Re Profile Park Power Plant– Planning Compliance (SD21A/0167)

**Profile Park Power Plant
Planning Compliance Report**
Application Reference: SD21A/0167

Planning Compliance Report Application Reference: SD21A/0167

Document Control Sheet	
Document Reference	11069
Report Status	Issue
Report Date	05/10/2022
Current Revision	D02
Client:	GREENER IDEAS LIMITED
Client Address:	C/O Centrica Business Solutions, 1 Seapoint Building, 44-45 Clontarf Road, Dublin 3, D03 F4A7
Project Number	11069

Cells highlighted Indicate Pipe is to be incased in concrete, where the cover is less than 1.2m in Roads, as per detail on DWG 11069-2042

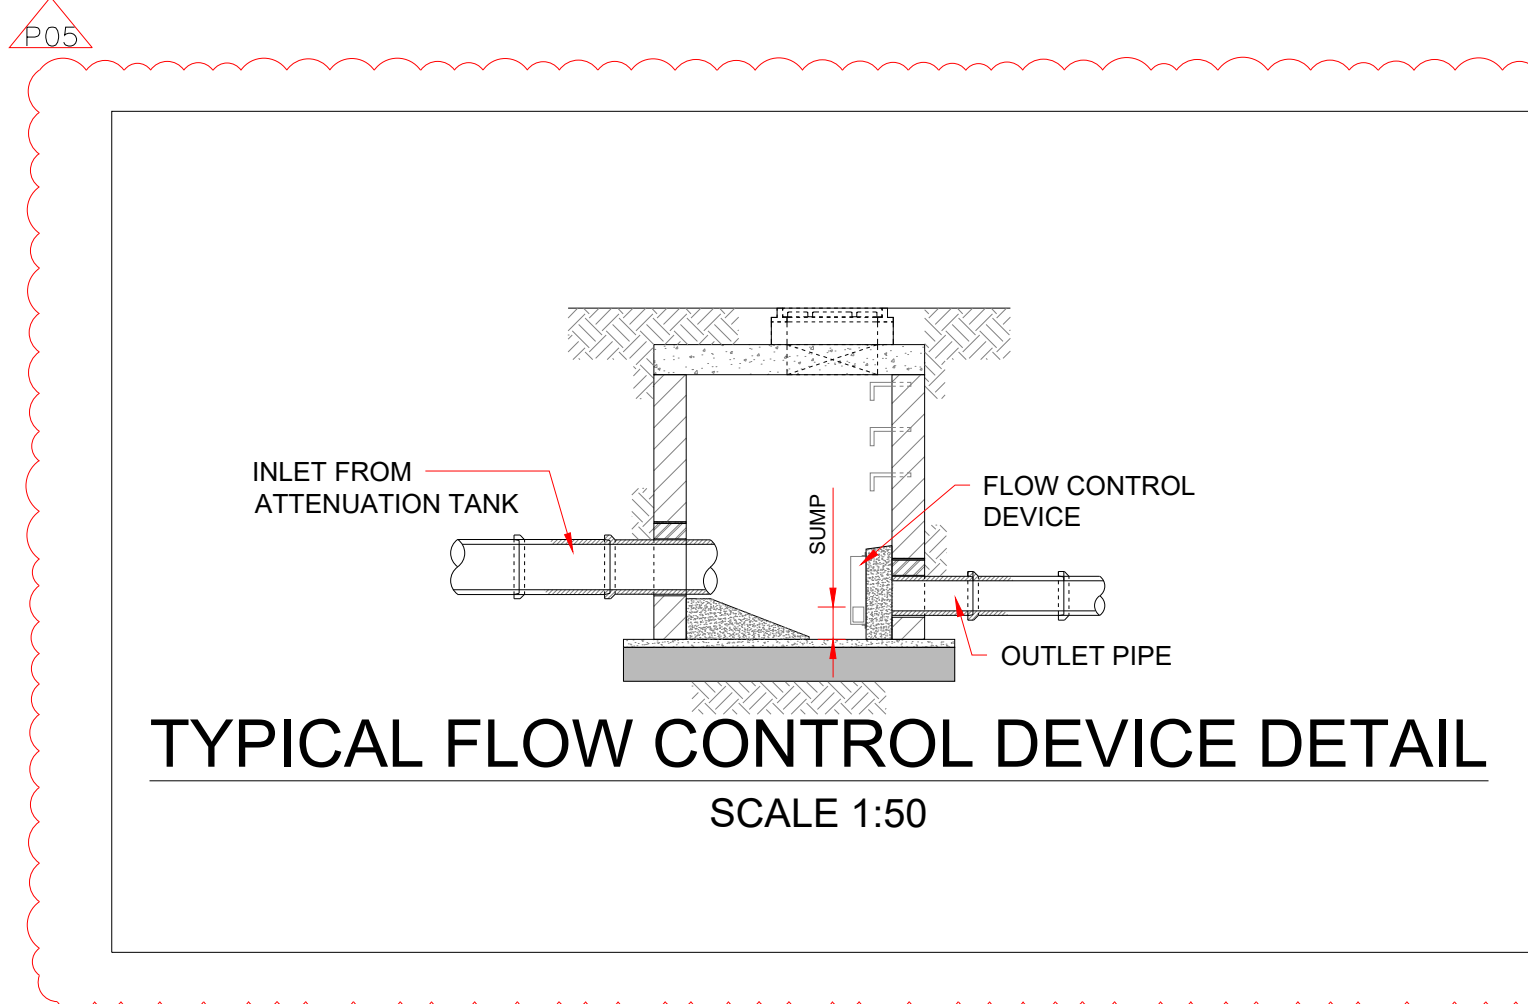
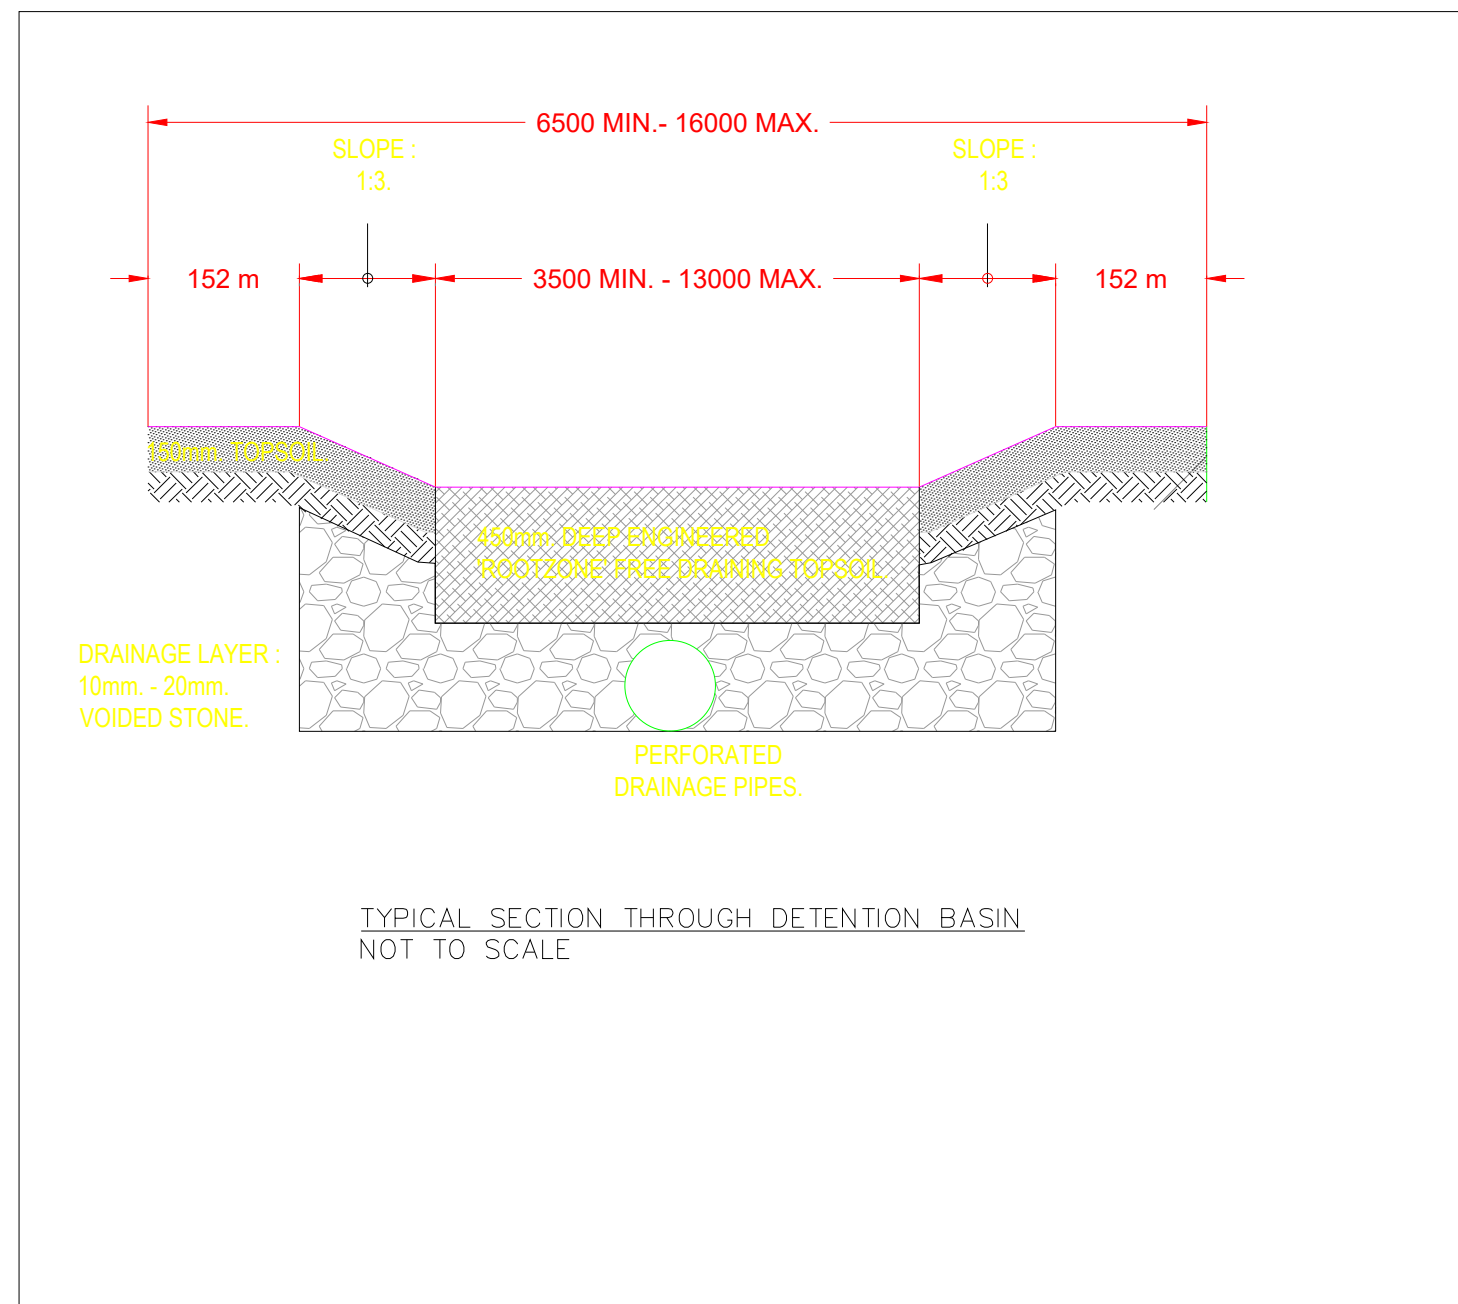
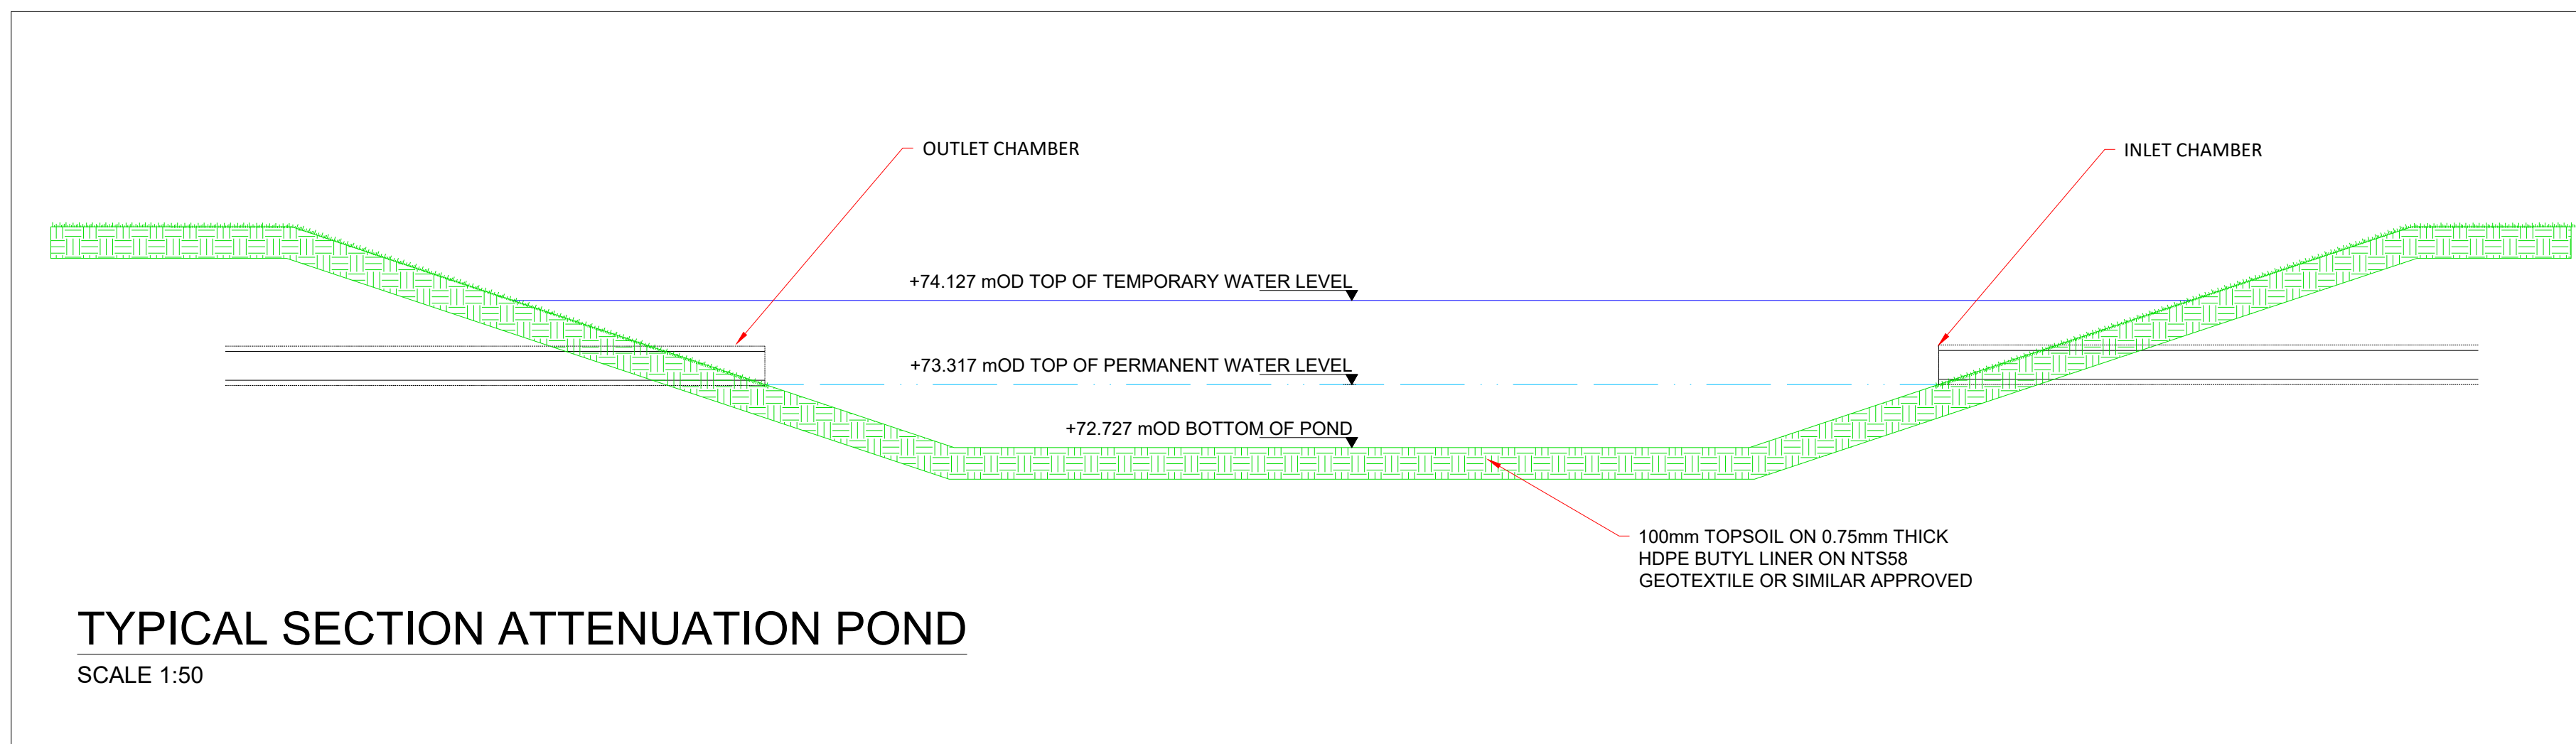
- (a) Prior to commencement of development, the applicant shall submit a drawing showing where and how surface water discharge from site will be limited to a maximum of 3.8 litres/second.
- (b) Prior to the commencement of development, the applicant shall submit revised drawings which provide adequate SuDS and omit the underground attenuation and petrol interceptors, unless otherwise agreed in writing by the Planning Authority.
- (c) All fuel storage proposals on site shall comply with the Greater Dublin Regional Code of Practice for Drainage Works Section 17. All process water and any effluent from the development shall not discharge to the surface water drainage network.

With regards to item (a) above, please see Appendix 4 for an updated site layout plan no. 11063-2010_P04, which shows the location of the proposed Hydrobrake at manhole S14. The design head for the Hydrobrake is 1.80m.

With regards to item (b) above, the originally proposed underground attenuation tank has now been omitted from the design and replaced with a cleaned crushed stone detention basin to allow for storage of surface water runoff, treatment and infiltration of stored water into the groundwater. Please see Appendix 4 for updated plan no.s 11069-2010_P04 and 11069_2036_P05.
